SUBJECT: ISSUANCE OF AMENDMENT NO. 79 TO FACILITY OPERATING LICENSE  
NO. NPF-8 REGARDING STEAM GENERATOR TUBE PLUGGING - JOSEPH  
M. FARLEY NUCLEAR PLANT, UNIT 2, (TAC NO. 77236)

AMENDMENT NO. 79 TO FACILITY OPERATING LICENSE NO. NPF-8 - FARLEY, UNIT 2

SAFETY EVALUATION BY THE OFFICE OF NUCLEAR REACTOR REGULATION  
SUPPORTING AMENDMENT NO. 79 TO FACILITY OPERATING LICENSE NO. NPF-8

Figure 2.1-1 Reactor Core Safety Limit  
Three Loops in Operation

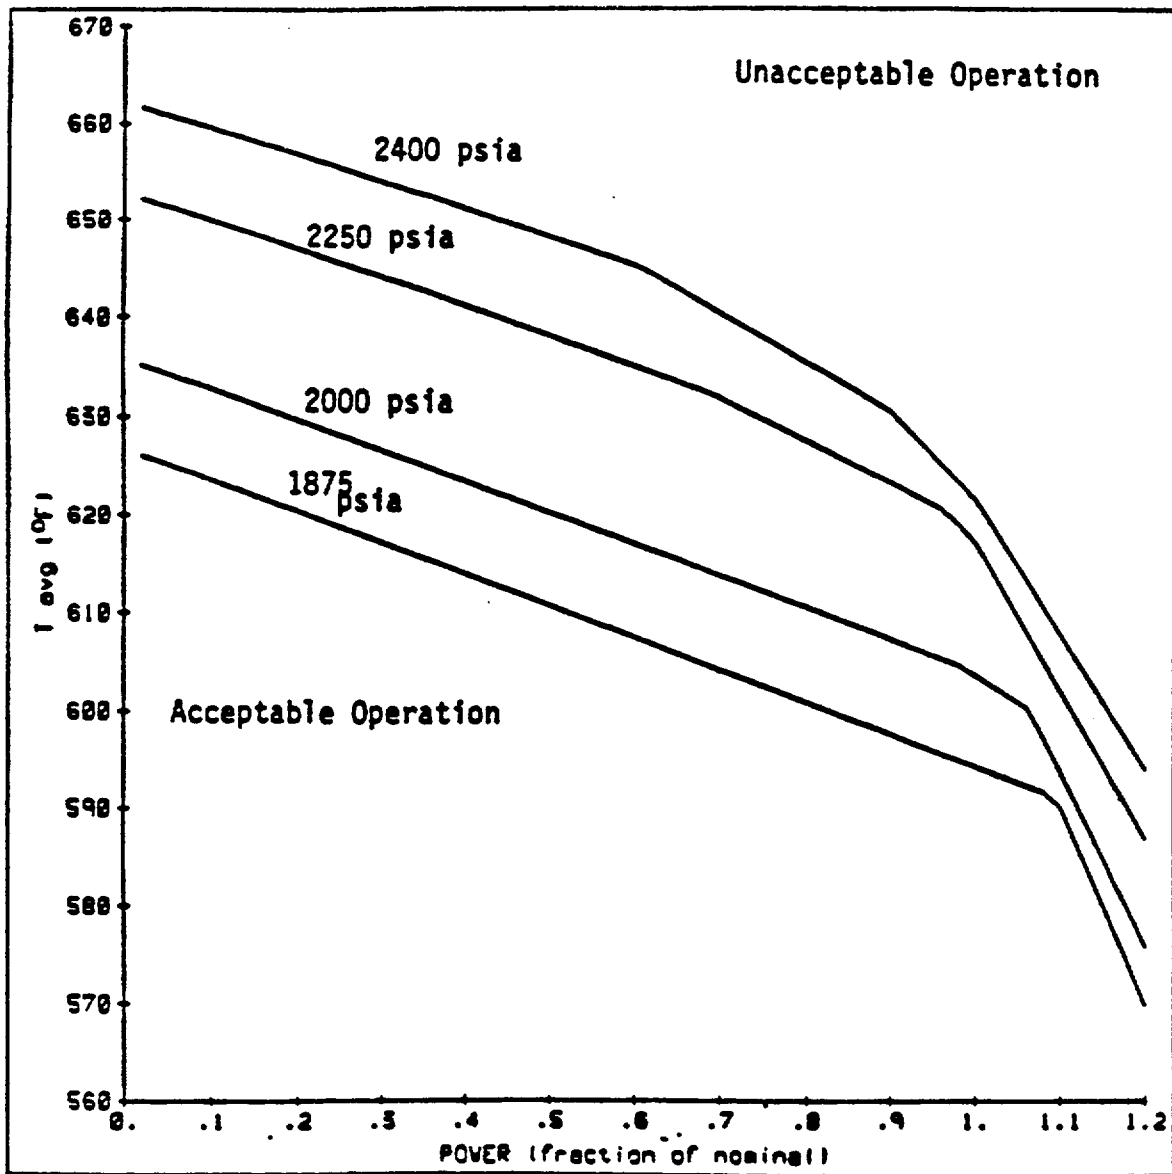
Farley, Unit 2, currently has a steam generator tube plugging (SGTP) limit of 10% based on the large break loss-of-coolant accident/emergency core cooling system (LOCA/ECCS) analysis as shown on Technical Specification Figure 2.1-1. Based on APCo operating experience, it is expected that the number of steam generator tubes requiring corrective action in Unit 2 could exceed the current SGTP limit of 10%. Therefore, APCo has requested a change to the Technical Specifications to increase the SGTP limit from 10% to an average 15% SGTP with a peak limit of 20% SGTP in any one steam generator. Also included in the request is a reduction of approximately 1.5% in the reactor coolant system thermal design flow.

The licensee proposed changes to the Technical Specifications which involve approval to increase the equivalent tube plugging limit from the current licensed value of 10% uniform plugging to a new licensed value of 15% average with a 20% peak in any one steam generator. The specific plugging limit is removed from the Technical Specifications, consistent with the Westinghouse Standard Technical Specifications. Also included is a decrease of approximately 1.5% in reactor coolant system total flow rate from the current licensed value of 265,500 gpm to a new licensed

The amendment changes the Technical Specifications to allow an average of 15 percent steam generator tube plugging with a peak of 20 percent in any one steam generator. The amendment also includes an approximate 1.5 percent reduction in the reactor coolant system thermal design flow.
